Memo

File No: OCP07-0022 / **Applicant:** Meiklejohn Architects Inc.
Z07-0073

At: 477 Osprey Avenue **Owner:** Al Stober Construction Ltd.

Purpose: To amend the OCP Future Land Use Designation from the "Multiple Unit Residential - Medium Density" Designation to the proposed "Commercial" Designation.

REZONING

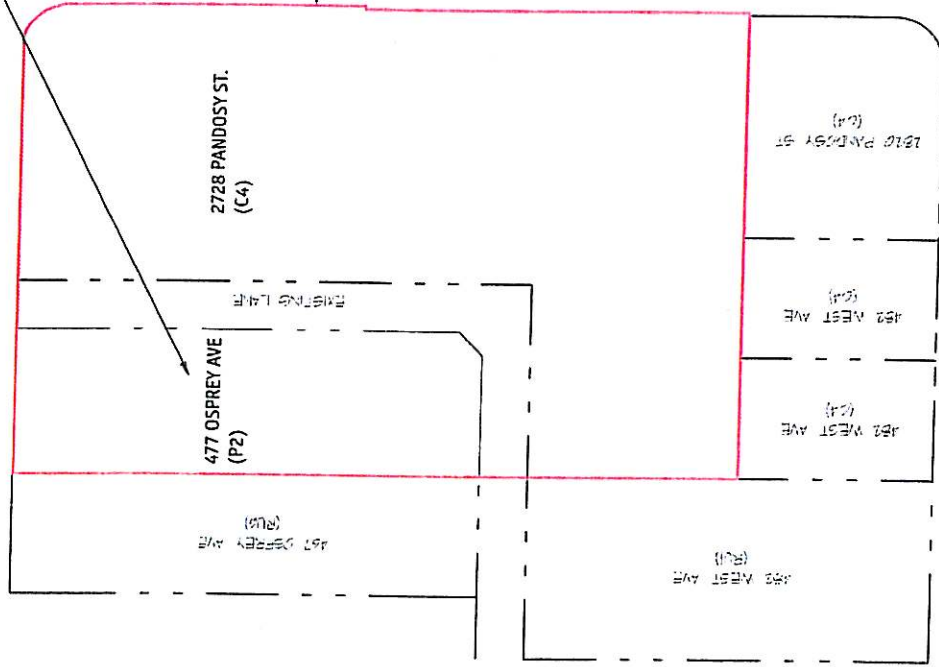
1. Works and Utilities requirements for this application were addressed in City file No. DP07-0198 and are still valid.
2. Provide a 6.0m corner rounding (road reserve).
3. A lane dedication of 6.8m must be acquired from the subject property to the existing lane.
4. 3.0m x 2.7m (ultimately 3.0m) lane truncation is required.
5. Provide 1.80m widening (road reserve) along the 26.52m length property line.
